Fast-track RFI Response 2 - Landscape

Proposed Solar Farm
The Point, Mackenzie Basin

23 February 2026

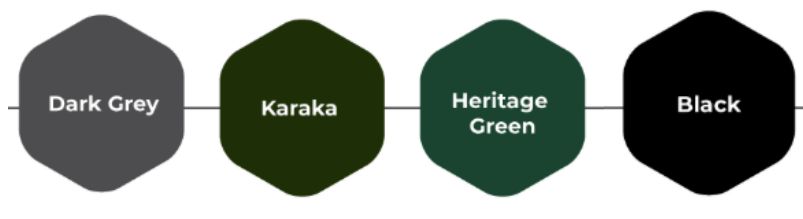
Response to RFI 6.1.b

The condition relating to colours states (underlined for emphasis):

“All transformers, water tanks and structures on Site must be coloured in a dark, natural and recessive colours within the hues of greys, greens and browns which have a light reflectance value of less than 30%. Any externally visible part of a transformer, water tank and / or other structure that is externally visible cannot meet the light reflectance value requirement, the Consent Holder must submit written justification to Mackenzie District Council for certification prior to installation.”

Figure 1. Illustrating the distance between the boundary and the Landscape Mitigation Vegetation.

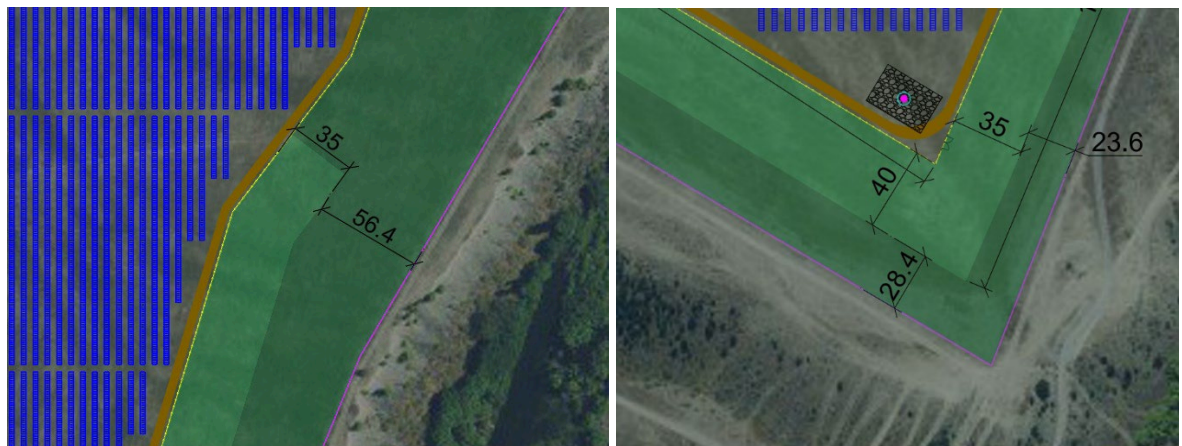
Mr Ewan has raised concern about the landscape mitigation vegetation and irrigation near the Threatened and At-Risk Species and the potential for cross boundary effects.

The Landscape Plan is at 1:5,000 scale, being quite far out so the proximity of the landscape mitigation vegetation in relation to the boundary was missed. The updated design plans in RFI 1 Response in Appendix 10, and **Figure 1** below illustrates that the landscape mitigation planting is set back more than 20m from the boundary line. Therefore, all plants and irrigated areas are at least 40m from that At-risk plant species.

As per 9 above, the purpose of irrigation is to ensure survival and establishment of the native vegetation for the initial three years. Therefore, 'overwatering' is not intended, that may otherwise occur from leaving an automatic irrigation system on for too long. Rather, irrigation will be via water crystals and / or a truck / tractor with a boom arm with a direct top-down spray. The accessways and offset areas enable the irrigation to be sprayed 'into' the Site and away from the At-risk plant species. Noting, irrigation will not occur during strong wind days when spray may drift south and east of the site.
